## RESPONSE TO REQUEST FOR ADDITIONAL INFORMATION

### APR1400 Design Certification

Docket No. 52-046

RAI No.: 151-8078

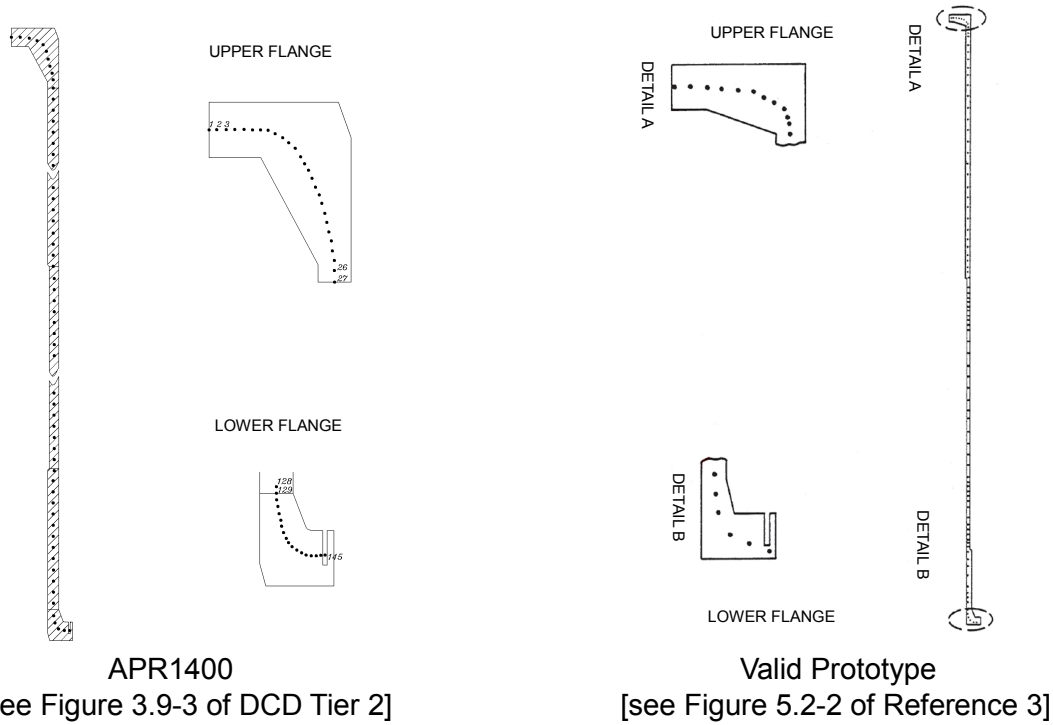
- Comparison of the response amplitude time variation and the frequency content from test and analysis for verification of the postulated forcing function

Comparison of the pump pulsation pressures is provided for the following components.

It is noted that the RMS pressures are used as inputs to calculate the pump-induced pressure loads across the components as described in Reference 1.

1) CSB Model

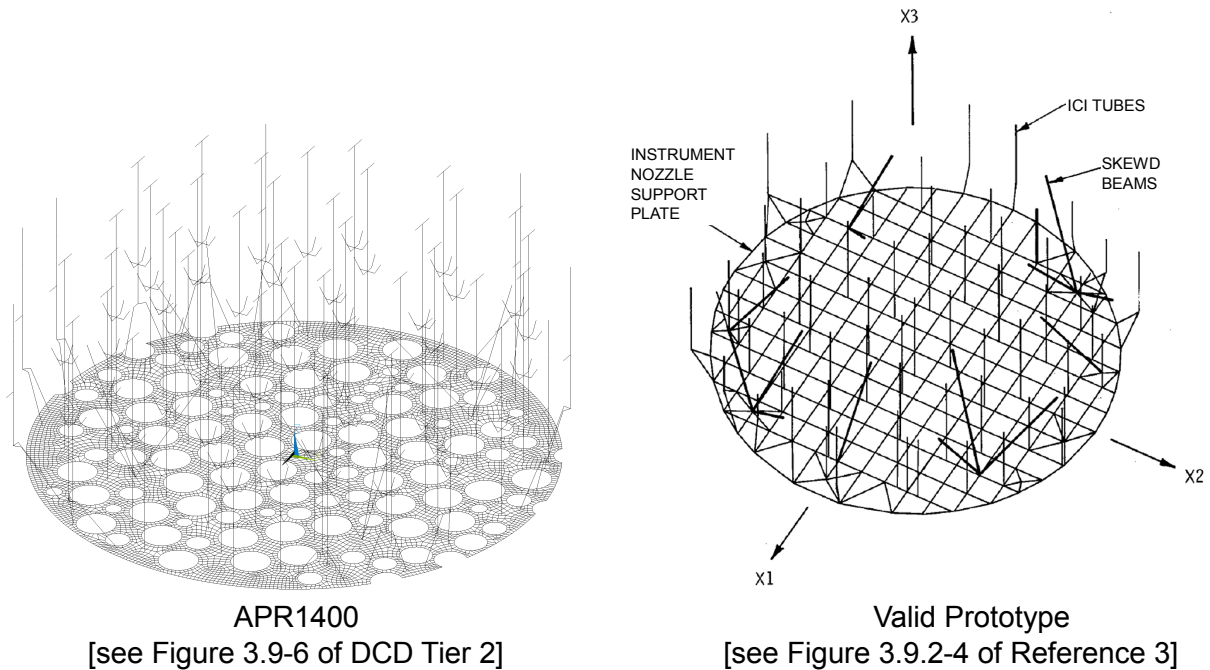
- Comparison of the maximum responses from test and analysis for verification of stress levels
- Comparison of the mathematical model for dynamic system analysis under operational flow transients and under combined LOCA and SSE loadings between APR1400 and valid prototype plant.

- A comparison of the mathematical model for dynamic system analysis under operational flow transients and under combined LOCA and SSE loadings between APR1400 and valid prototype plant is provided as follows:

5) Reactor Internals Horizontal Model for Dynamic Analysis

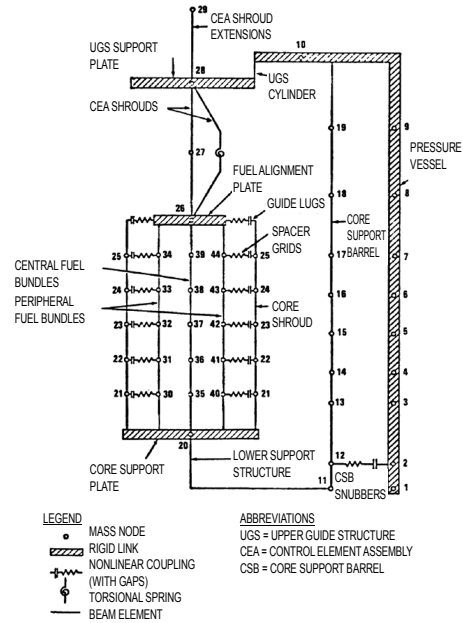
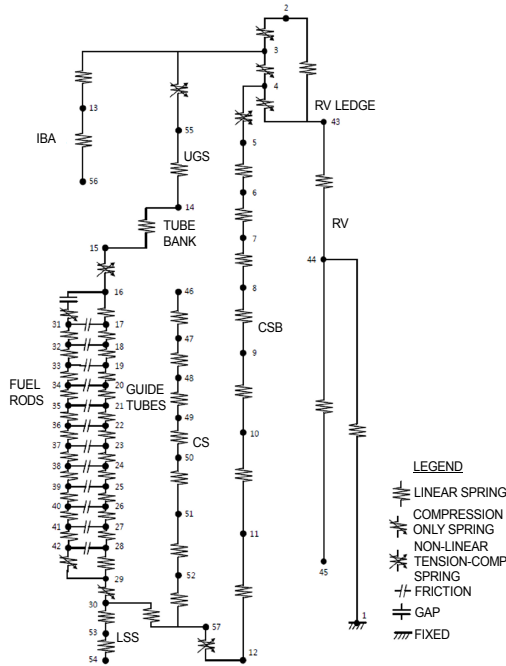
DCD Tier 2, Section 3.9.2.5.1 states that the seismic dynamic analysis of the reactor internals including the core is performed separately for the horizontal and vertical directions. The nonlinear horizontal model, as shown in DCD Tier 2, Figure 3.9-16, was constructed to consider gaps between internal components (between core and core shroud, and between core support barrel and reactor vessel) and the large relative displacements occurred during the SSE event. The vertical non-linear model (DCD Tier 2, Figure 3.9-18) was constructed considering the possibility of the core assembly lifting off the support plate. The applicant further states that the mathematical model also includes hydrodynamic effects. However, the staff did not find that Section 3.9.2.5 provided information regarding fluid-structural interactions for the models shown in Figures 3.9-16 and 3.9-18.

[see Figure 3.9-16 of DCD Tier 2]

[see Figure 3-4 of Reference 5]
